REMARKS

IN THE DRAWINGS

Please replace the previously filed formal drawings (Figure 1 and Figure 3) with the attached new formal drawings. Two Amended drawing sheets showing changes and two replacement drawing sheets are enclosed.

FIG. 1

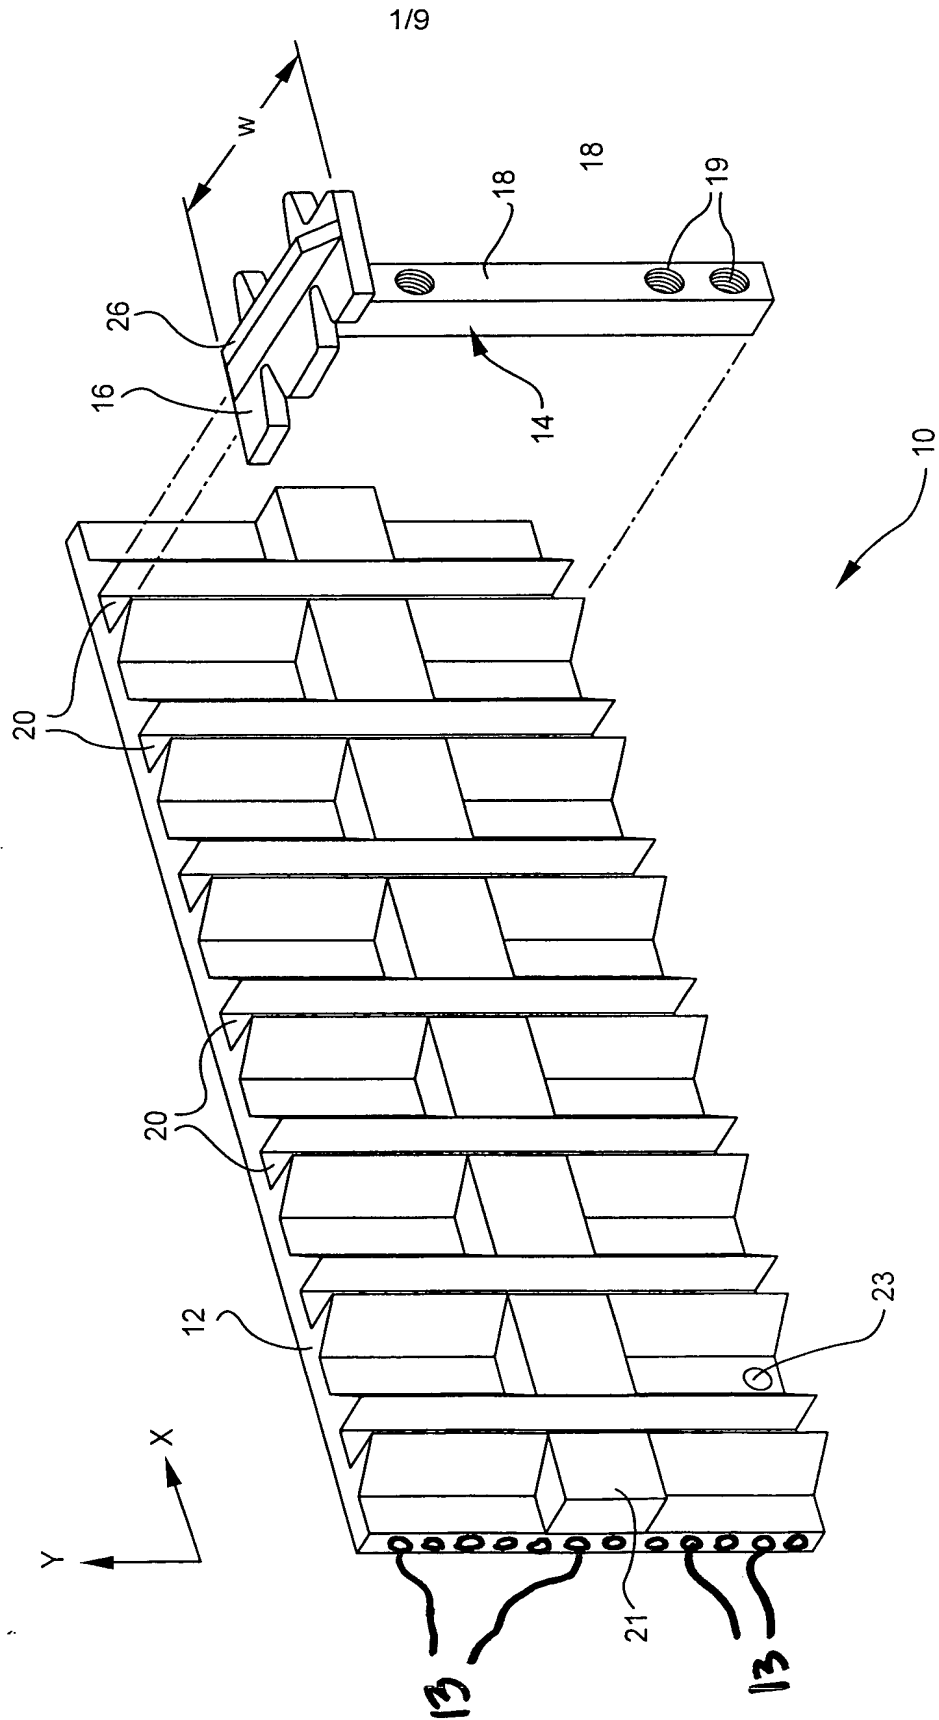
In the Office Action, the drawings were objected to on several grounds. Figure 1 has been amended to show the longitudinal wires 13 running through the belt. No new matter has been added, as the wires were referred to in paragraph 20 of the specification. The drive surface 28 of the vertical portion of the belt is clearly shown in Figure 3, and the sensor opening 23 is clearly shown in at least Figure 5 and amended Figure 3.
